RE: Turkey Point Unit 3 and Unit 4  
Docket Nos. 50-250 and 50-251  
Fourth 10-Year Inservice Inspection Interval  
Response to Request for Additional Information for Relief Request No. 15

**FPL Letter L-2015-172**

**Relief Request No. 15**

**Request for Additional Information (RAI)**

85% - "UP" LOWER FLANGE

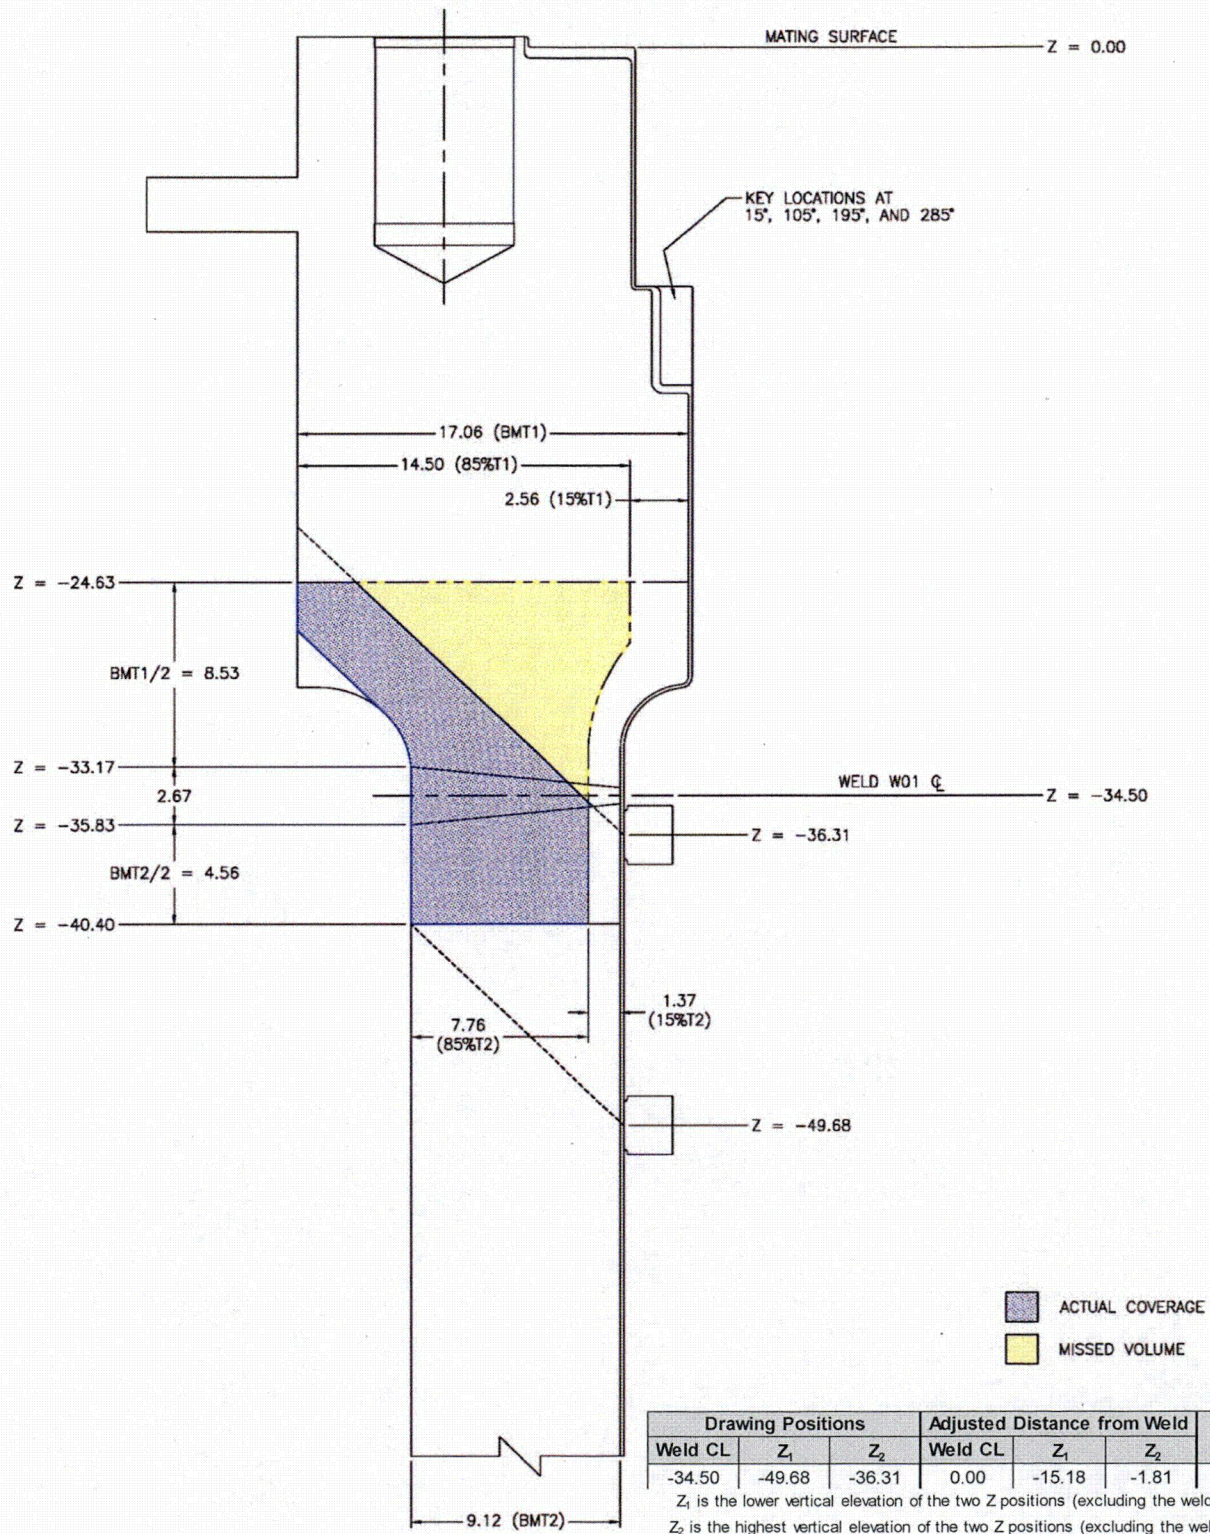
With respect to Figure 5 for Category B-A, Item B1.30, Upper Shell to Flange Welds (Weld 3-WR-18 for Unit 3 and 4-WR-18 for Unit 4), provide the following information in a diagram showing: (1) the ASME Code, Section XI required examination volume, (2) the scan angles and axial distances of the search units from the welds used for the examination, and (3) the actual scanned volumes for both the axial and circumferential scan directions. Please refer to the industry/NRC information exchange public meeting held on January 13 -15, 2015 (ADAMS Accession Number ML15013A266), for a discussion of the NRC staff's expectations for the content of an inspection diagram (see Slide 12 for an example).

- (1) The ASME Code, Section XI required examination volume is illustrated on pages 12 through 23 of this enclosure. The examination volume includes the weld and 1/2 "T" of the base material on each side of the weld for the complete through wall thickness.
- (2) The scan angles and axial distances of the search units from the welds used for the examination are located on the inspection diagrams on pages 12 through 23 of this enclosure. The search unit shown in the illustrations does not reflect the actual size of the UT head configuration. Refer to Figure 1 of the original relief request.
- (3) The actual scanned volumes for both axial and circumferential scan directions are located on page 11 of this enclosure.
